CRANBROOK DISTRICT COUNCIL

Consultation Response - 15/1825/MOUT

Subject: 15/1825/MOUT - Proposed Development to the South of B3174 Rockbeare

15/0371 - Proposed Development to the South of B3174 Rockbeare

Figure 1. Potential development areas that have reduced landscape and visual impact

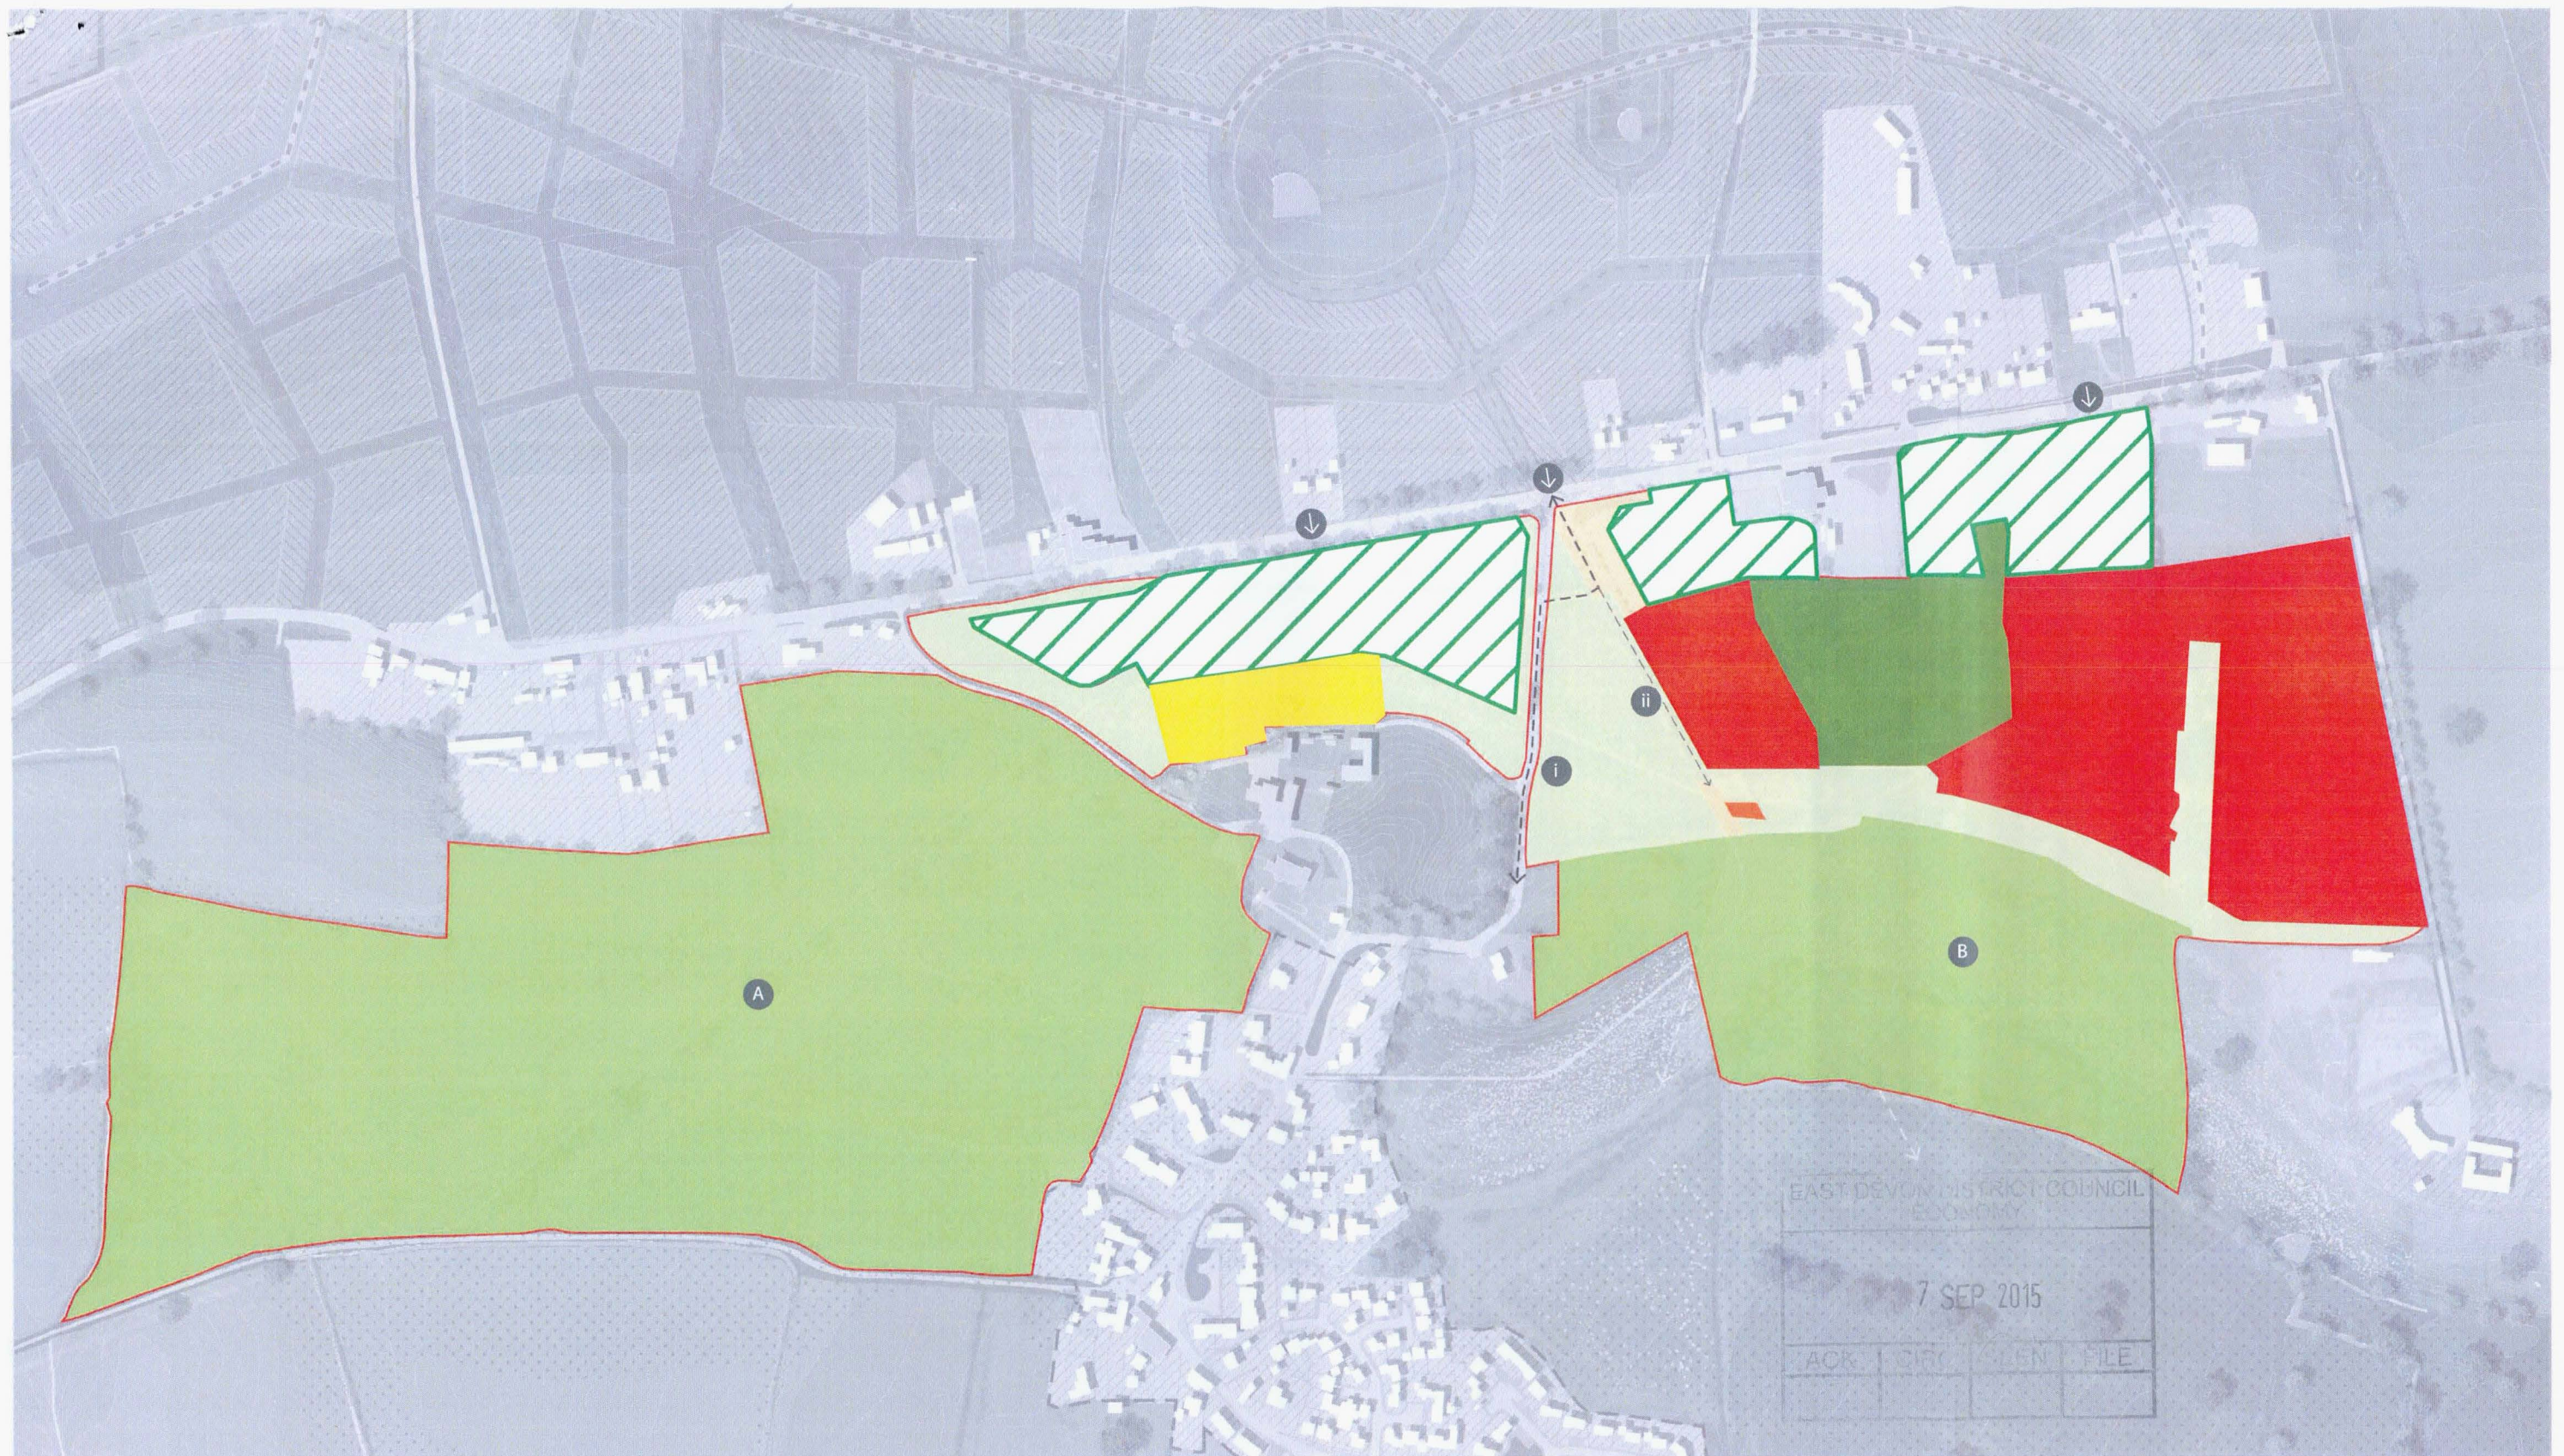
- The location of the proposed café is remote and visually intrusive and should be closer to the existing developed areas.
 - A more limited road frontage development, as indicated on Figure 1, could be acceptable, as it will have a more limited impact on the character of the local landscape and would be visually much better contained. It would be more in keeping with the development form seen along this part of the London Road.

- The access to the site from London Road will need to be reviewed if the considerable reduction in house numbers recommended were to be deemed acceptable. This should result the retention of more of the roadside hedging.
